[Docket No. FAA-2011-1231; Directorate Identifier 2011-NM-088-AD; Amendment 39-17418; AD 2013-08-01]

Airworthiness Directives; The Boeing Company Airplanes

ACTION: Final rule.

Figure 1, Fastener Removal of the Retainer Support on the Left Thrust Reverser Half

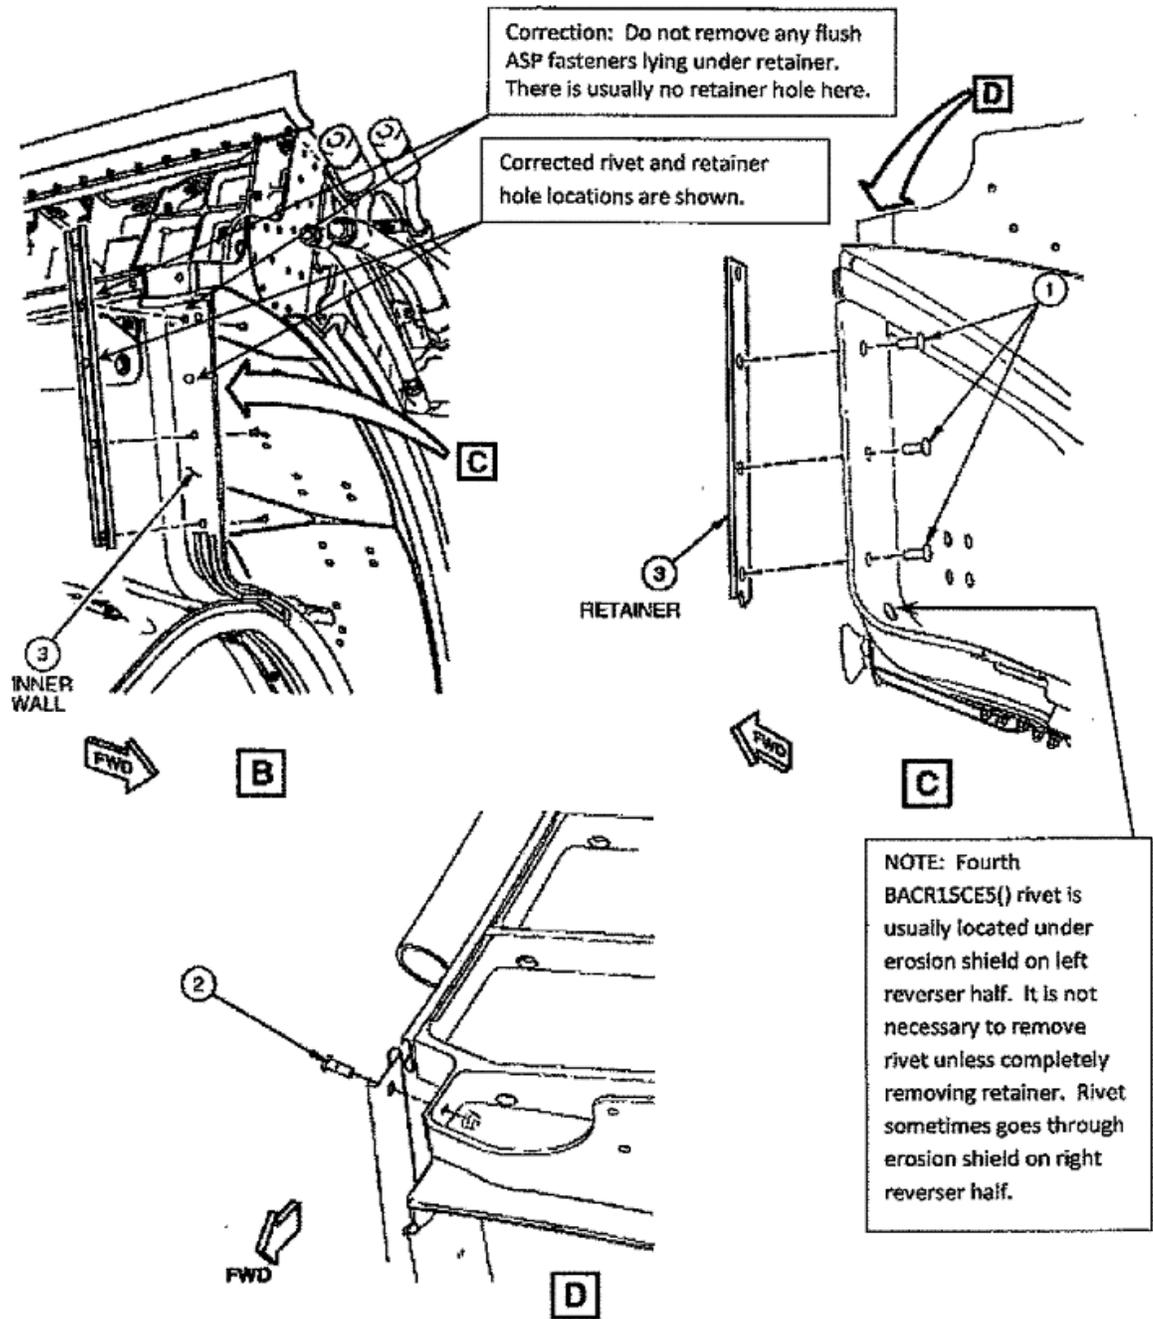
- Figure 10, Sheet 3 of 3: Note row (a) of the table shown in Figure 10, incorrectly refers the reader to "(a)" instead of Note row (b).
- Figures 6, 7, 15, and 16, all Sheet 2 of 3, all View B: These illustrations show the top fastener to be removed in the center of three fasteners in order to remove the retainer. However, these three fasteners are adjustable sustained preload (ASP) fasteners that do not require removal for this action. View B also incorrectly shows the location of the top rivet hole, which is actually below the row of ASP fasteners. These errors in those figures affect the actions specified in paragraph (g)(2) of this AD. The other instructions in the figures are correct.

(2) Figures 1 and 3 of this AD, titled "Fastener Removal of the Retainer Support on the Left (Right) Thrust Reverser Half," have View B showing the top fastener in the center of three adjustable sustained preload (ASP) fasteners. That top fastener does not require removal in order to remove the retainer. The figures in this AD point to the correct information for those fasteners.

Figure 2, Installation of the New Bracket behind the Retainer Support on the Left Thrust Reverser Half

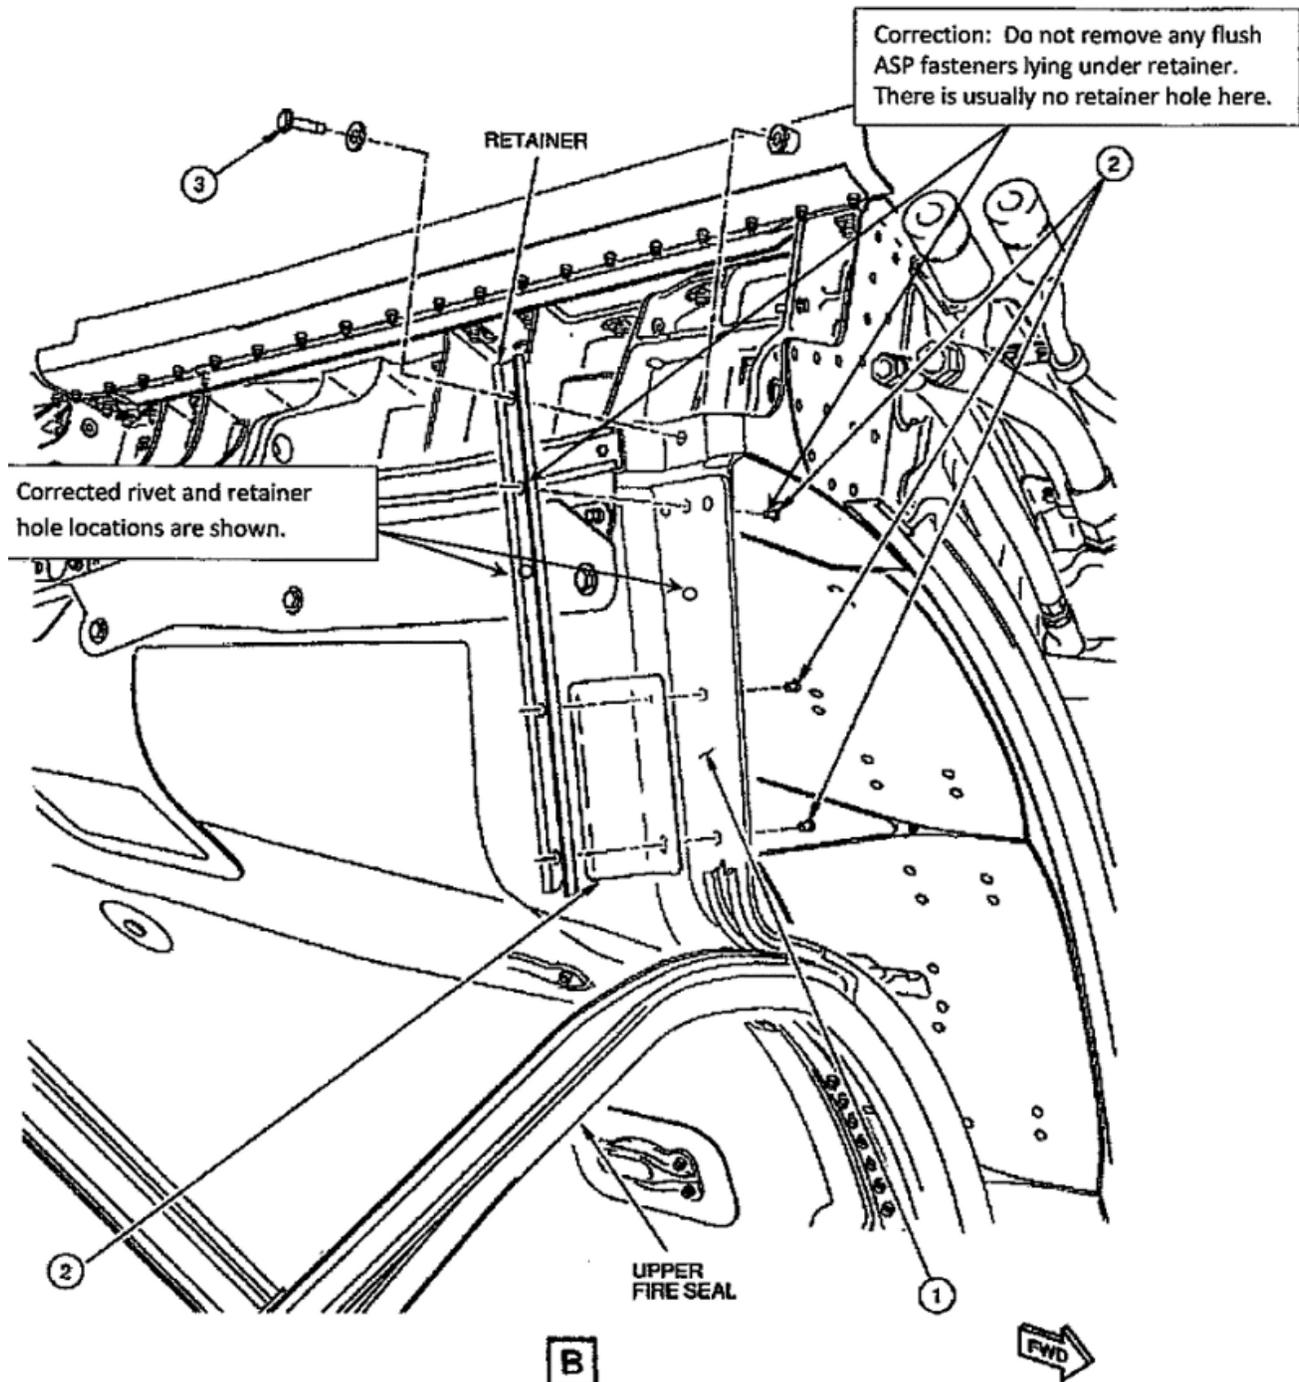
(3) Figures 2 and 4 of this AD, titled "Installation of the New Bracket behind the Retainer Support on the Left (Right) Thrust Reverser Half," have View B showing the top rivet hole. That rivet hole is actually below the row of three ASP fasteners. The figures in this AD point to the correct information for those rivet holes.
